HISTORIC DISTRICT COMMISSION NOTICE OF DENIAL

Application Number: HDC2025-00250

APPLICANT & PROPERTY INFORMATION						
NAME: Timothy Killeen	ME: Timothy Killeen		COMPANY NAME: N/A			
ADDRESS: 2018 11th St.		Detroit	STATE: MI	ZIP: 48216		
PROJECT ADDRESS: 2018 11th St.						
HISTORIC DISTRICT: Corktown						
SCOPE: Install brick veneer to foundation, replace porch spindles, install pavers and landscaping in berm area						
At the Regular Meeting that was held on 06/11/25 above-referenced application. Pursuant to Section amended, being MCL 399.205 (1), MCL 399.209 (9) the DHDC hereby issues a Denial for the following the Secretary of Interior's Standards for Rehabilitat	5(1) and 9) and Se work, eff	9(1) of the Michigan ections 21-2-78 and 2 ective on 06/17/25	Local Historic Distri 1-2-80 of the 2019 , as it will be inappr	ct Act, as Detroit City Code;

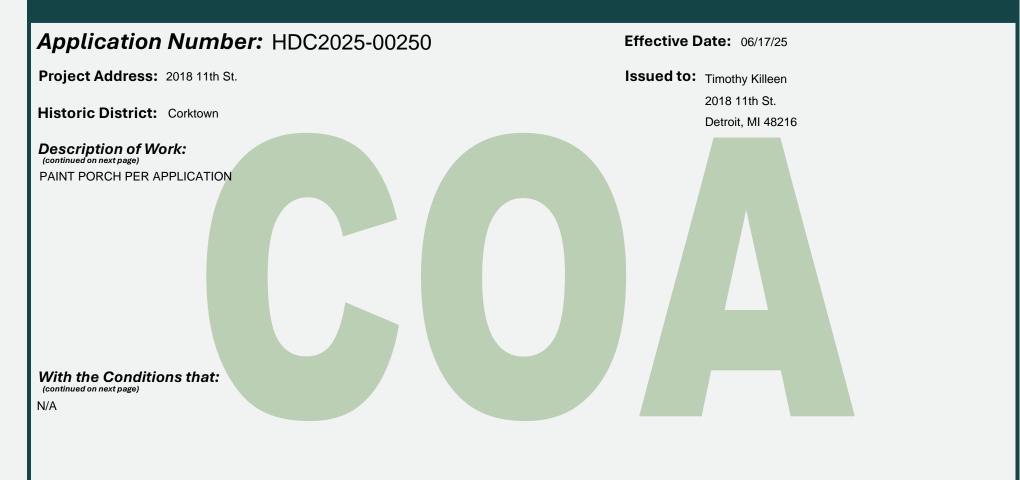
· Will the brick pattern and mortar be the same as the photo provided?

- Description of type of mortar to be used with the brick
- · Selected paint color(s) and placement
- Spindle design (this can be hand drawn or a product screenshot)
- Site plan of brick placements in berm (this can be hand drawn)

- Paint color and placement noted in attached photo

- Site of bricks on berm noted in attached photo

BLACKISH GREEN (treads, floor)

LIGHT YELLOW (accents)

MODERATE REDDISH BROWN (secondary color on posts, spindles, gingerbread)

BLACKISH GREEN (main color on posts, railings)

CARVE-OUTS FOR PLANTS

BRICK ON MAJORITY OF BERM (in straight or herringbone pattern, as permitted)
